Product Change Notification: PCN-23-189250

PCN Date: 10-OCT-23

zSFP plus stack type cage assembly

230919 2 Piece
Side Spring.pdf

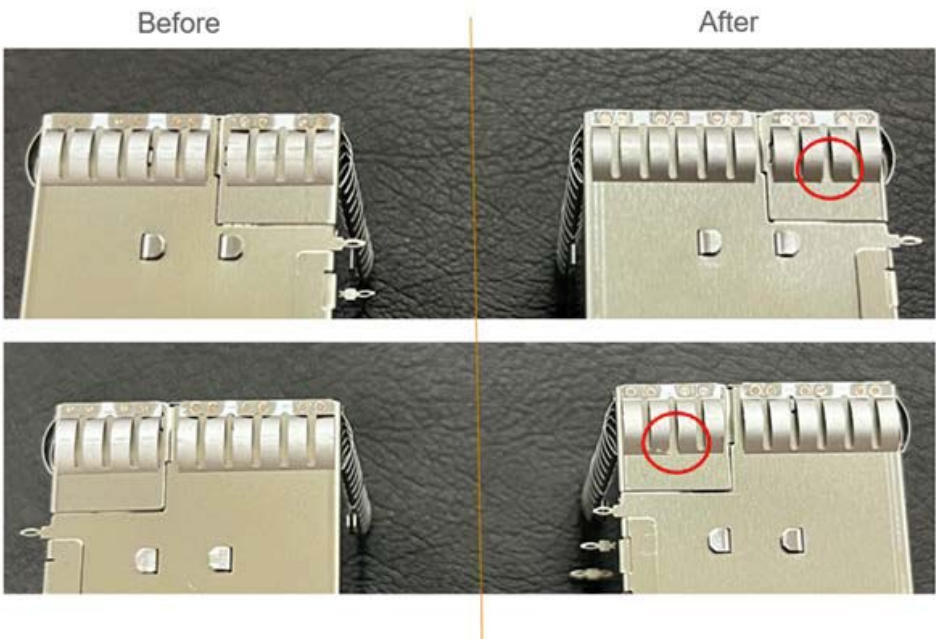
Please be aware of an upcoming feature change to the listed part numbers. Details difference see attachment. Before: Low EMI spring is one piece type After: Low EMI spring is cut into two piece type Per EMI testing, the minor change does not impact EMI performance

Because of EMI spring tooling was streamlined, so all stacked cages will be use one type EMI spring.
